KeContact

P30 x-series Charging Station Software Release Notes V 1.19.6

32.2.3 Connector ID assignment

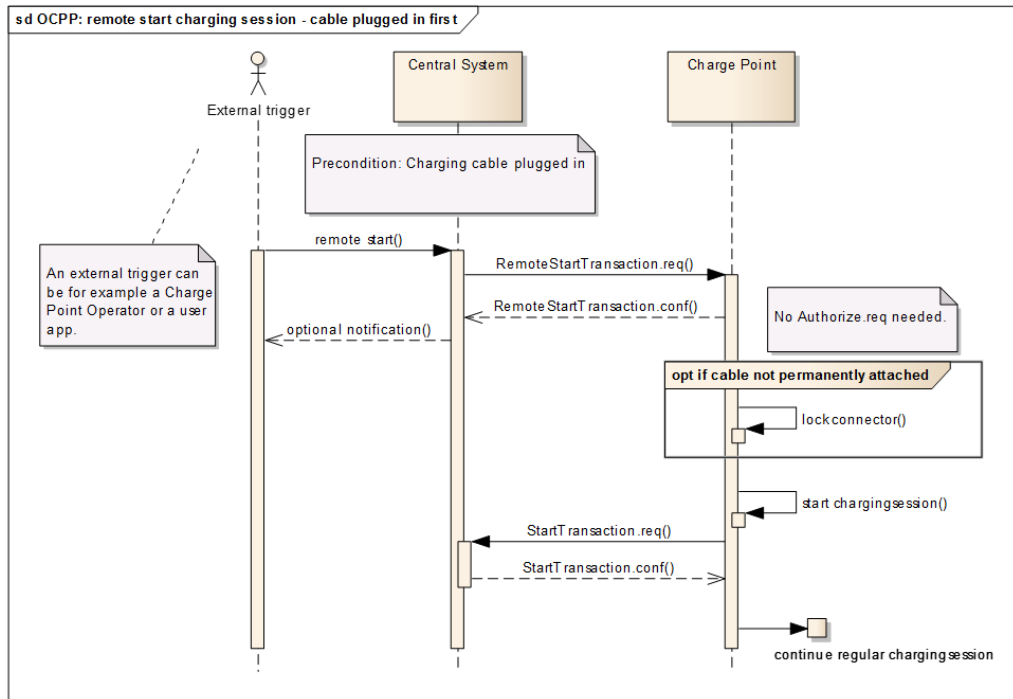
The user can assign the connector ID to a specific serial number directly via the web interface.

Remote start charging session – cable plugged in first

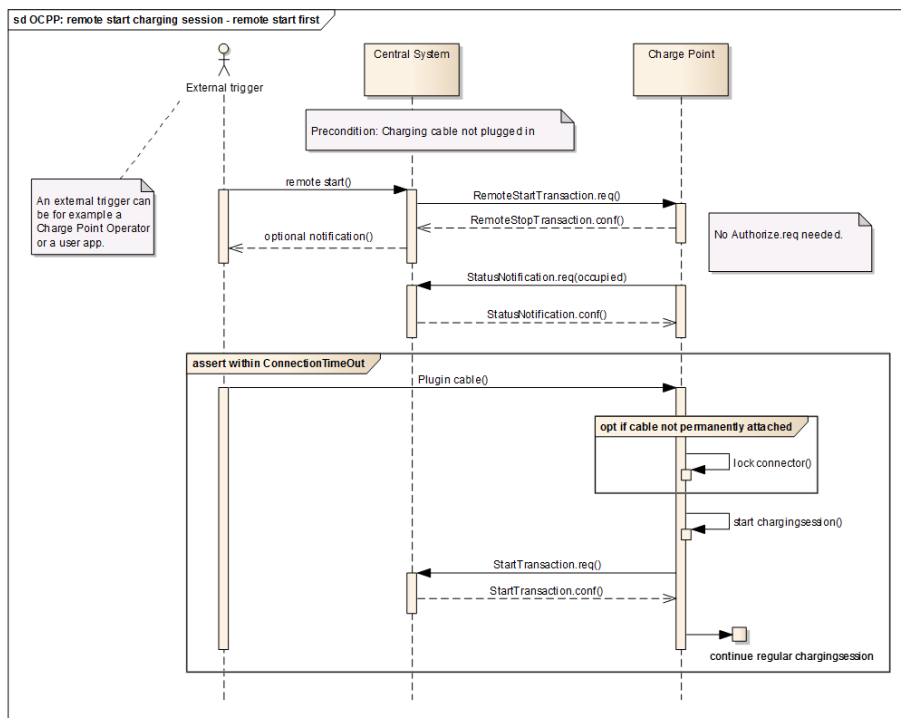
The Remote Start Transaction sequence has been modified so that the P30 replies immediately after receiving the Remote Start Transaction request.

33.2.9 New feature: WIFI

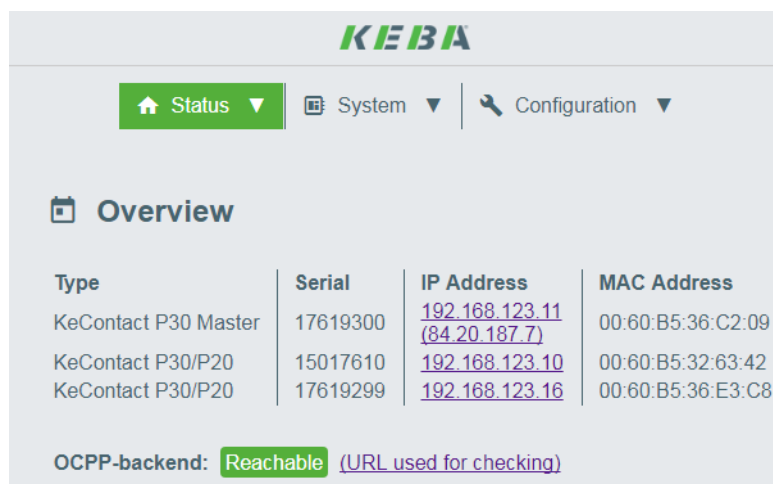
With this new feature it is now possible to activate the already built-in WI-FI module in the electronics of the KeContact P30 x-series.

You can configure your KeContact P30 x-series to connect to an existing WI-FI network or to be used as hotspot. For more details on how to configure and use the WI-FI function please read the configuration manual.

33.2.13 Authorization Disabled

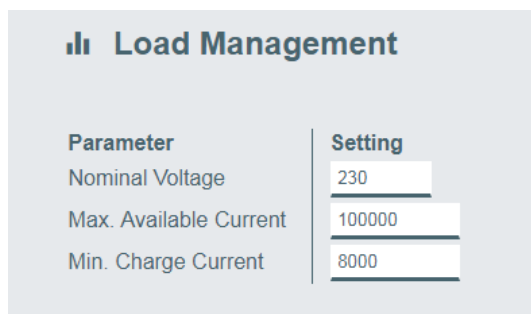
When the Authorization in the WebUI is set to OFF, the LEDs of the P30 Master and clients will flash green.

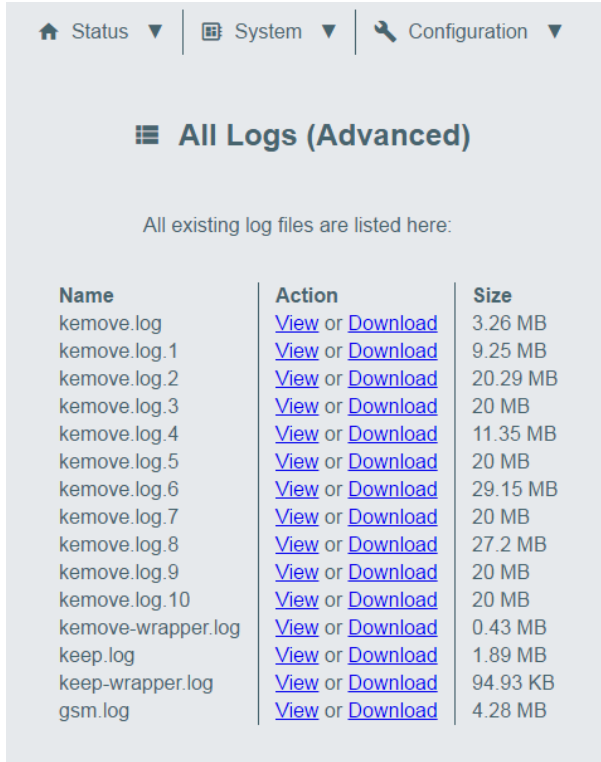
Added "All Logs" button to "Logging" tab, allows individually viewing and downloading every single log file.

Here is shown a screen shot of what the user can see if clicking on “ All Logs”.

35.3.7 WebUI – component version

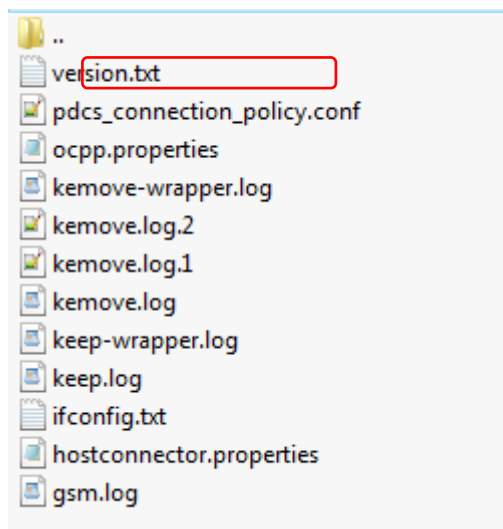
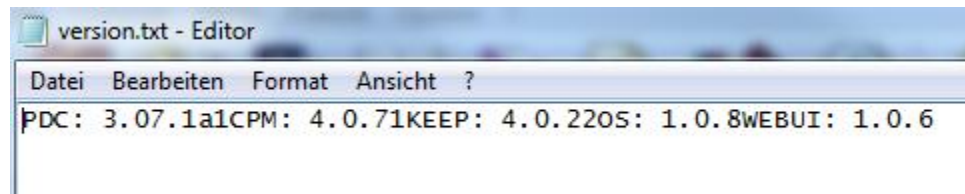
Added the text file “version.txt” in zip file accessible by clicking on "Download Latest".

In this file are enclosed the information related to the versions of the software component.
